Intersection ID: 10019201	Main Street: WINTERFIELD_PL	Cross Street: N/A	Location:	E
ADA ID: 3FF3987DE7AB	Ramp Type: Perp	Initial Pass/Fail: Fail	Overall Compliance: No	Severity Score: 25

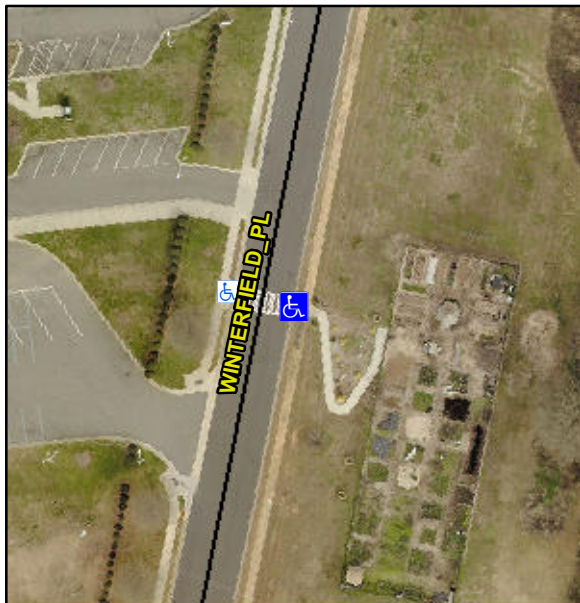
Codes/Mitigation Info/Possible Solution			Field Measurements/Component Compliance					
	Possible Solutions:		Compliance	Description	Data	Compliance	Description	Data
	Remove & Replace Entire Ramp.		N/A	Ramp Length (in)	28.0	No	Ramp Slope (%)	14.5
			Yes	Ramp Width (in)	48.0	Yes	Ramp XSlope (%)	0.8
			N/A	Flare Type LT	N/A	N/A	Flare Type RT	N/A
			N/A	Flare Slope LT (%)	N/A	N/A	Flare Slope RT (%)	N/A
			N/A	Flare Traversable LT?	N/A	N/A	Flare Traversable RT?	N/A
			N/A	Landing Length (in)	N/A	N/A	DWS Provided?	N/A
			N/A	Landing Width (in)	N/A	N/A	DWS Contrast?	N/A
			N/A	Landing Slope (%)	N/A	N/A	DWS Length (in)	N/A
			N/A	Landing X Slope (%)	N/A	N/A	DWS Full Width?	N/A
Surveyor Notes:			N/A	Landing Curb? (Y/N)	N/A	N/A	DWS Offset (in)	N/A
			N/A	Shared Landing?	N/A			
PROW/ADA:			N/A	Gutter Ponding?	N/A	N/A	Gutter Slope (%)	N/A
Not Found, R304.2.2			N/A	Gutter Lip Ht (in)	0.5	N/A	Gutter X Slope (%)	N/A
			N/A	Painted X Walk1?	Yes	N/A	Painted X Walk2?	N/A
